Technical Service Bulletin

55 Paint abrasions on rear lid from tail lamps

55 23 78 2071125/1 August 4, 2023.

Model(s)	Year	VIN Range	Vehicle-Specific Equipment
Q4 e-tron, and Q4 e-tron quattro	2022 – 2023	All	Not Applicable

Figure 1. Rear lid tail lamp with an insufficient gap to the rear lid.

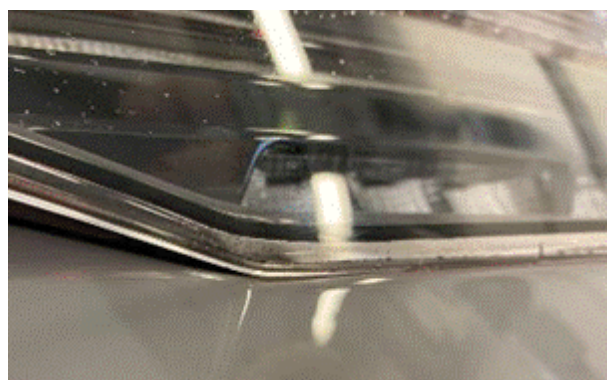
Workshop findings: The gap between the tail lamp and the rear lid is too small or non-existent causing contact to the rear lid and damaging the painted surface. In some cases the corrosion protection is also compromised and corrosion in the rear lid could be visually apparent.

Figure 1 shows a tail lamp to rear lid gap that is insufficient.

Insufficient clearance between the rear tail lamp and the rear lid creates contact between the two and damages the paint on the rear lid (figure 2).

The gap between the rear tail lamp and rear lid has been optimized in production to eliminate contact between the two (figure 3).

Any damage to the painted surface and/or corrosion protective surface on the rear lid will need to be repaired. Arrange this repair through your Audi Certified Collision Center. Before releasing the vehicle for the paint repair the buffers on the tail lamp will need to be modified to prevent subsequent paint damage.
